SAKURA SHOTEN / SITE CORRECTION / REV C

CAD first: rotated roof-only stair / millimetres / 23 October 2026 / opt-in game candidate

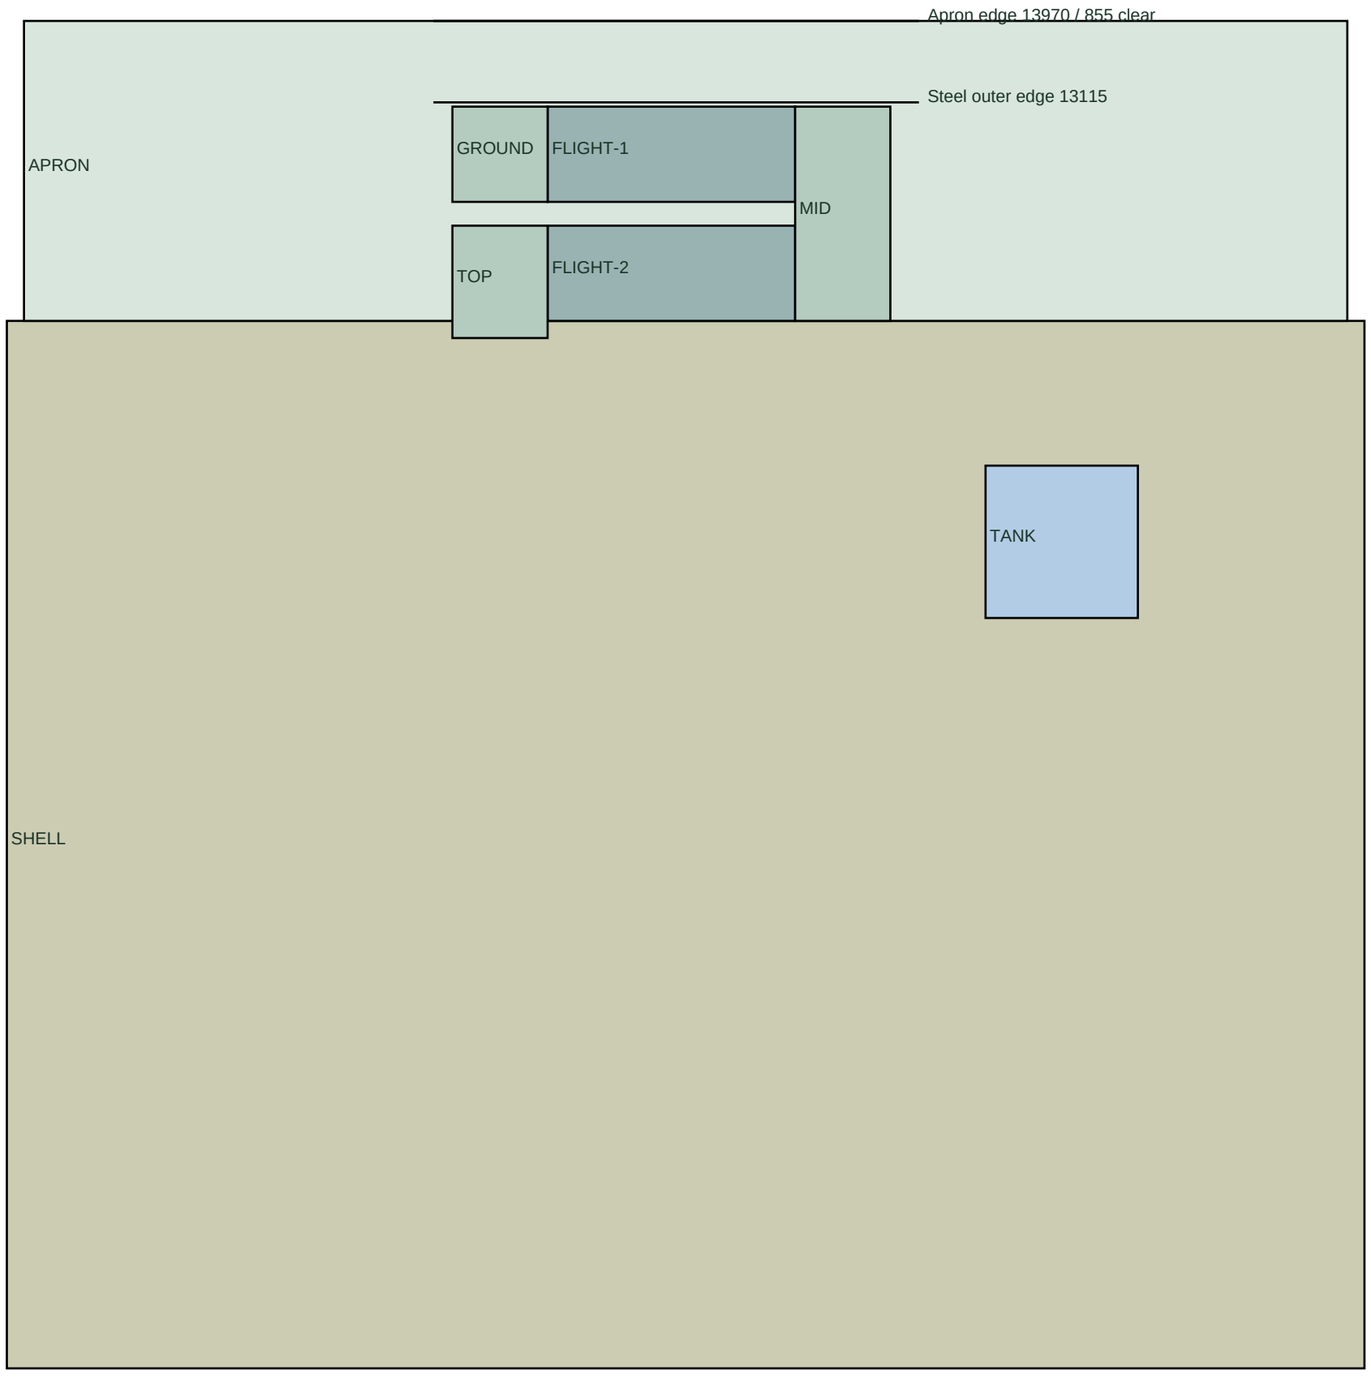
Old 4600 mm projection conflicts with the circuit.

Rotate U-stair: 4600 along wall x 2250 out.

Flights: 1000 tread / 956 between rails / 22 rises x 182.273 = 4010.

10 goings x 260 per flight; midpoint +2005.

Existing apron: 3150 out; outer passage 855 incl. steel.

Stair Z -29.45 to -24.85 stays within apron bay.

Delivery: CAD X10975-12025, clear of stair.

Move condensers to CAD X3200-4200, clear of bikes.

Remove obsolete upper shell and old escape ladder.

Four A2 posters retain all 20 wall notice positions.

No new roof entry prompt or traversable stair.
